Substantive Review Comments 1 - Part A, Permit Fee, Character Background Reference (CBR), and Corrective Action

Comments on General Information (Att A), Facility Description (Att B) and Container Management Plan (Att D)

SR4 – Comments On Waste Analysis Plan (Att C)

SR5 – Comments on Emission Standards Plan (Att O; Subpart CC)

AA Sydcoll Site Plan, 2264 13th Street, Yuma AZ (Ref. ADEQ Permit)

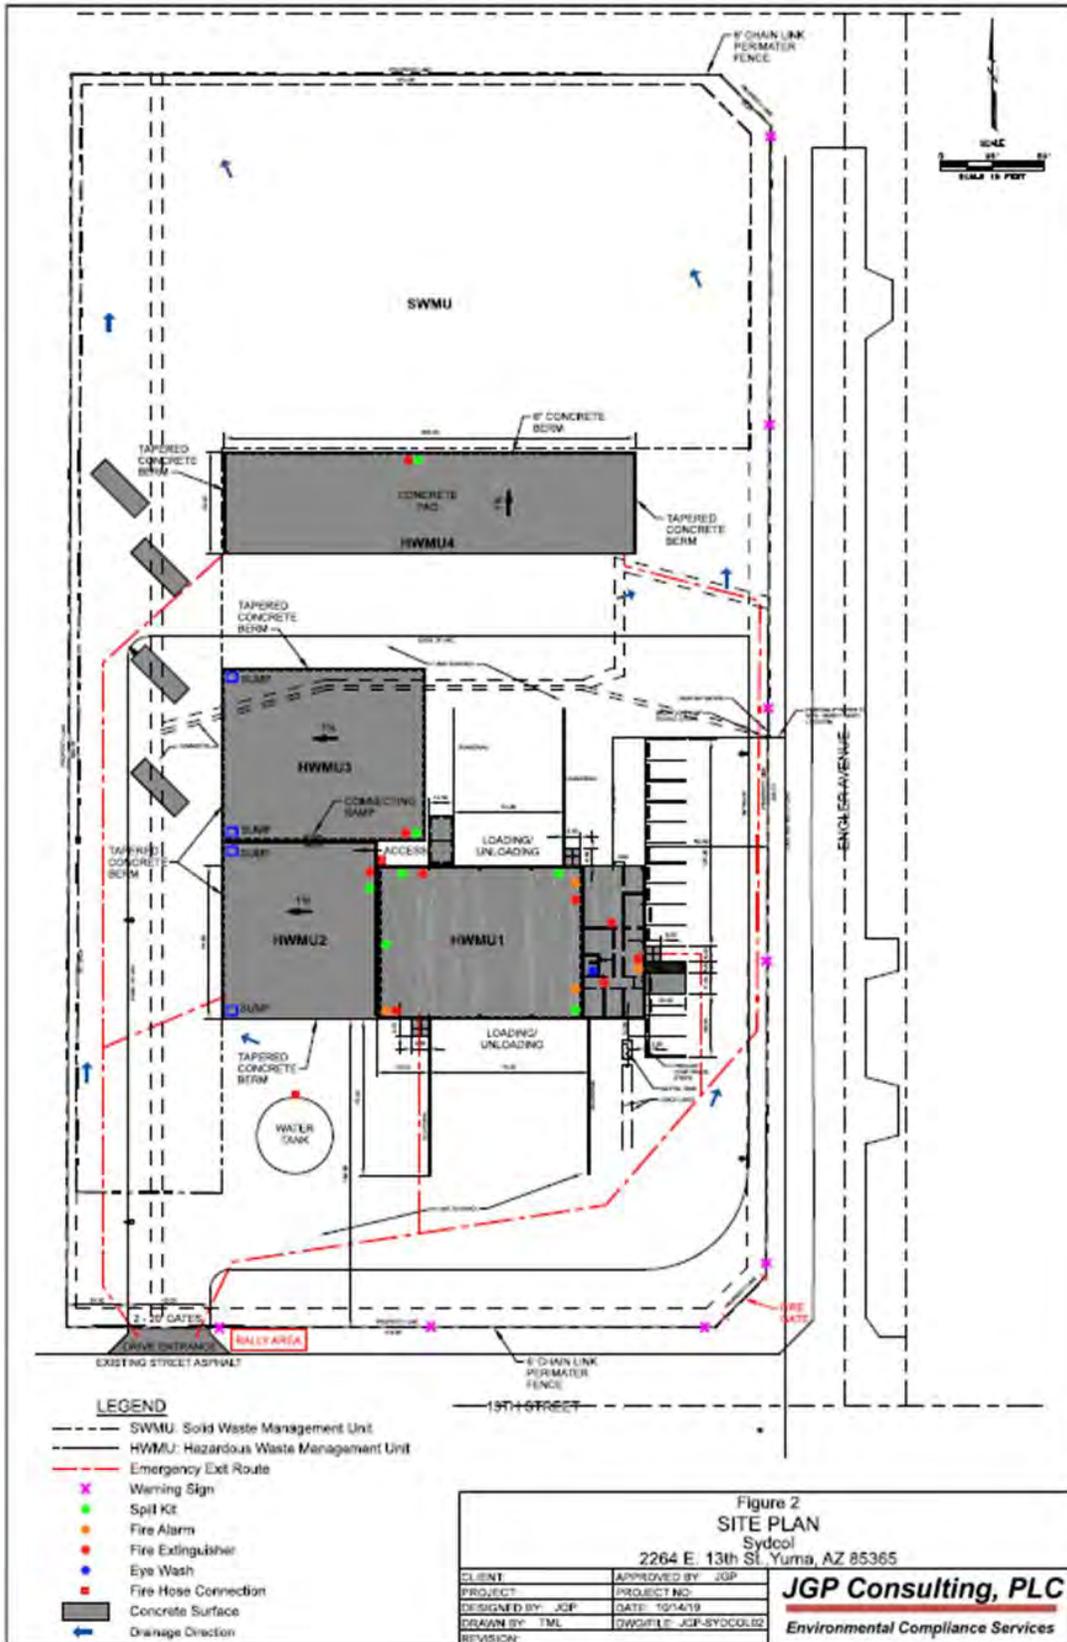
Typically, wastes will be transported to the Facility in tankers and/or containers (e.g. 55-gallon drums, totes) and will be liquid, semisolid, and/or solid in nature. Wastes will be received directly from generators or through third-party waste brokers under contract with hazardous and non-hazardous waste generators. An owner site plan, warehouse floor plan and photographs are provided in Att. 1, 2 and 3 respectively.

AA Sydcol Warehouse Floor Plan, 2264 13th Street, Yuma AZ (Ref. ADEQ Permit)

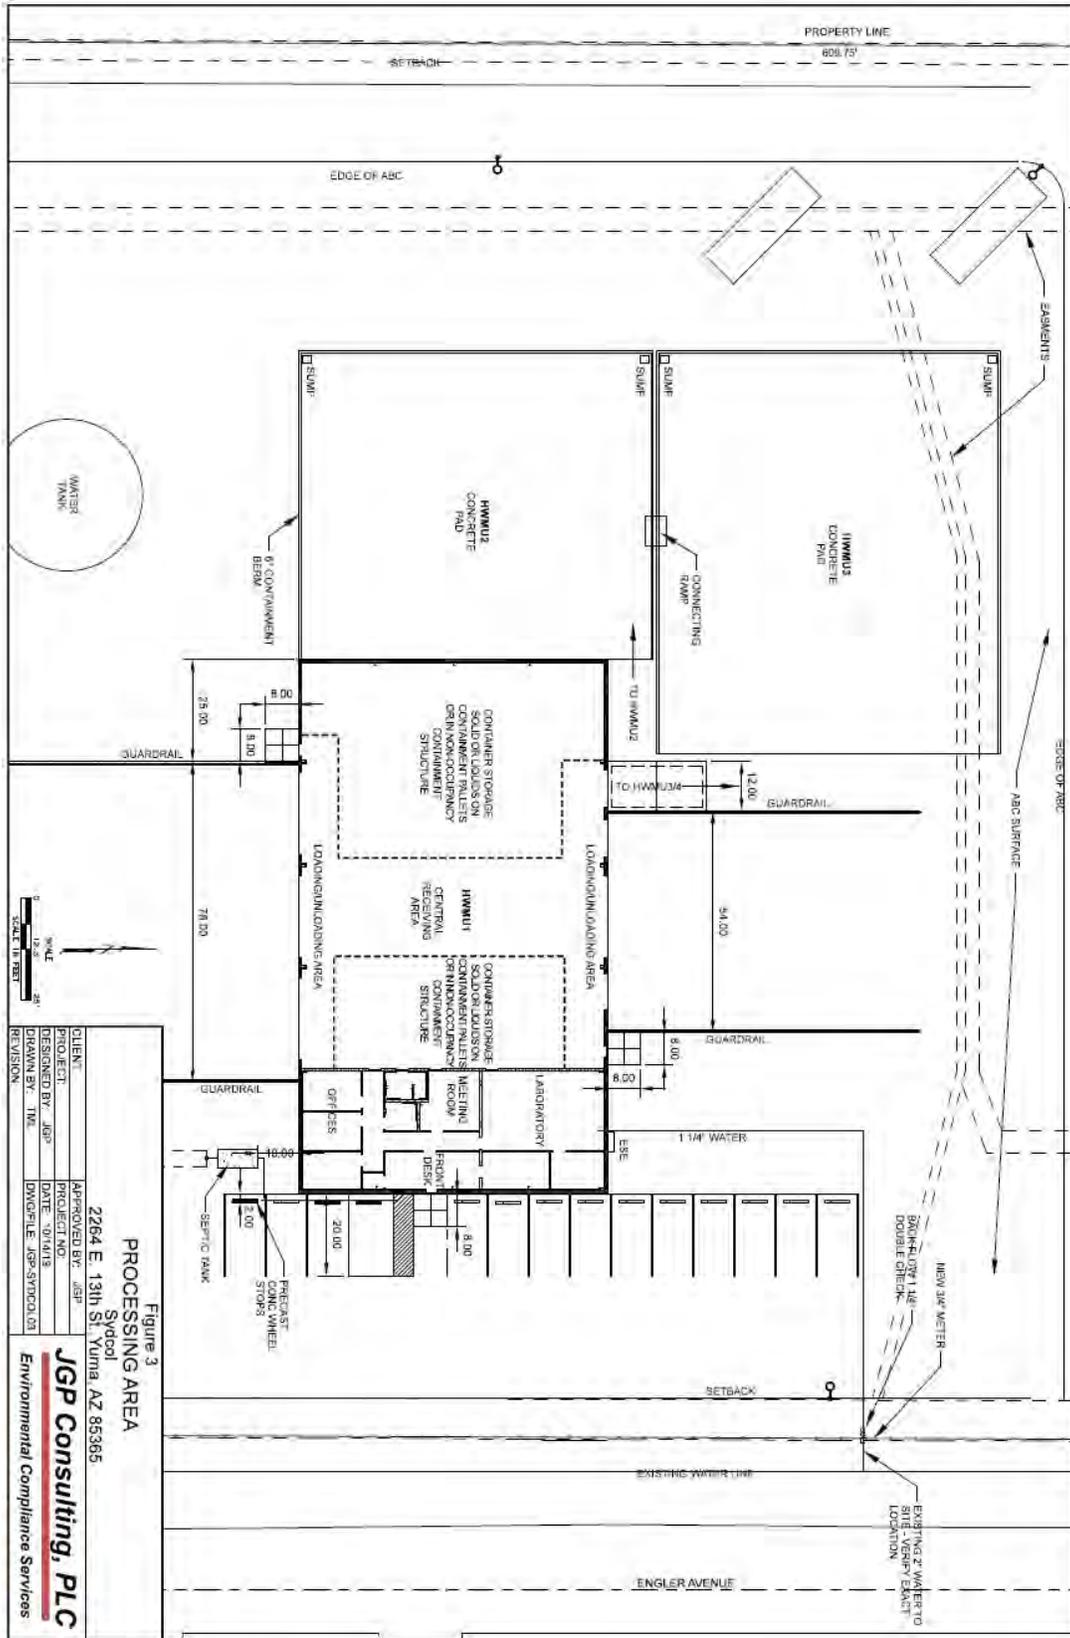
AECOM's preliminary review identifies the existing indoor facility is permitted as a processing plant and office storing non-hazardous materials in 2017 per the YCBC. The building was designed for Use Group Classifications of Factory Group F1 and Business Group B mixed-use separated occupancy of Type II-B non-combustible construction. The F1 Group is assumed to pertain to the open warehouse in the main building identified as Hazardous Waste Management Unit 1 (HWMU1). To maintain the F1 Group classification in that area, it is required to remain below the maximum quantity of hazardous materials identified by the 2018 International Building Code as amended by the City of Yuma. The maximum quantity of hazardous materials is further restrictive for transfer of liquids as described in the ADEQ permit application Att. D, Section 3.3.

Otherwise the F1 Group classification will change to a single or multiple High-Hazard Group H, including H-2 and H-3 for flammable and combustible liquids and H-4 for corrosive, toxic and highly toxic materials. The same approach applies to outdoor Group S Storage. A general layout of storage, a list of hazardous materials classified under RCRA, containment capacity diagrams and maximum drum storage by hazmat class from the ADEQ permit application are provided in Att. 3, 4, 5 and 6 respectively.

For compliance with 40 CFR § 264.31, AECOM recommends the owner perform a building, fire and hazmat code analysis in accordance with Yuma County for indoor and outdoor hazmat storage areas. This would directly mitigate the potential of a fire, explosion, or any unplanned sudden or non-sudden release of hazardous waste or hazardous waste constituents to air, soil, or surface water which could threaten human health or the environment. AECOM's review is primarily focused on flammable and combustible liquids, although limits are even more restrictive for other hazmats posing a health hazard such as highly toxic materials i.e. 1 gallon maximum, which the Owner is also responsible to comply with.

AA Sydcot Containment, 2264 13th Street, Yuma AZ (Ref. ADEQ Permit)

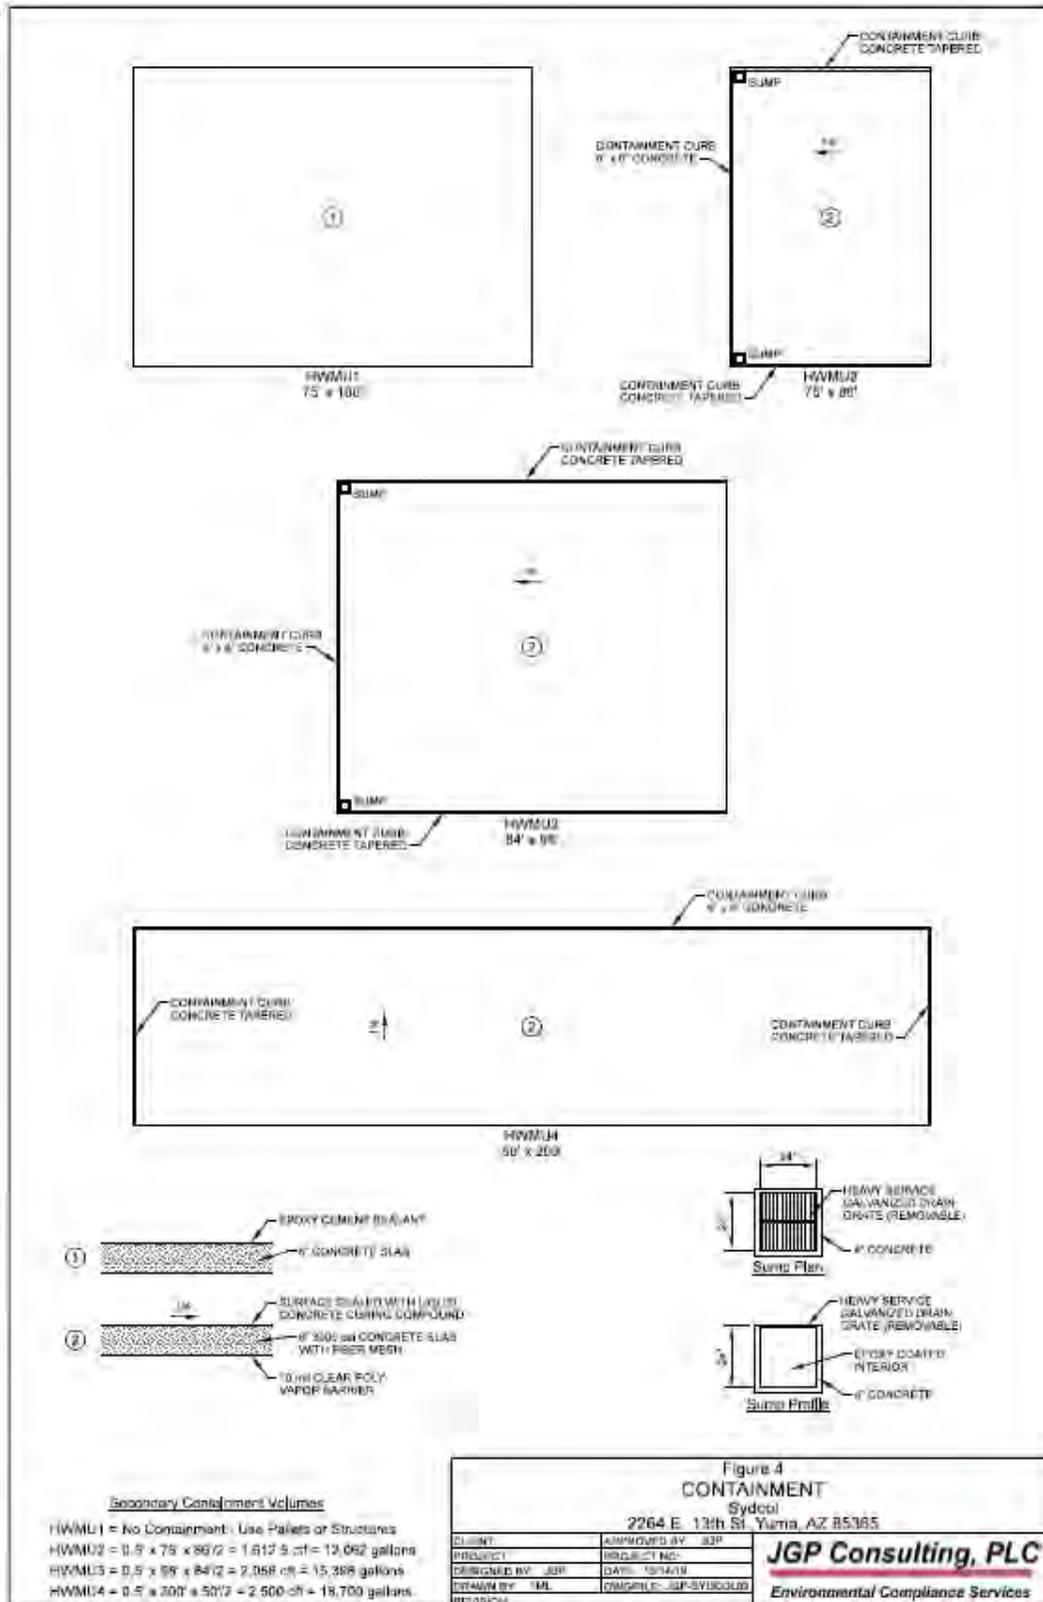
As shown in Table 1, the proposed containment volumes are all approximately twice the required minimum values. The sumps in HWMU2 and HWMU3 were not included in these calculations but can be discounted as the additional volume they provide would be negligible in this context. Run-on and run-off to the containment areas was also considered in this analysis. The site is largely sloped from South to North and run-on from the South and East will be contained by the street drainage systems along the facility boundaries. According to the Site Plan (Figure 2) in Attachment D, the site is sloped so that stormwater drains away from the containments and along the East and West sides toward the Northern end of the facility. Even during a 25-year, 24-hour storm, the proposed six-inch berms around the containment areas would prevent run-on from washing over into the containment. To ensure these conditions are not changed, during construction activities, the site must be graded to prevent run-off from entering the containment areas.
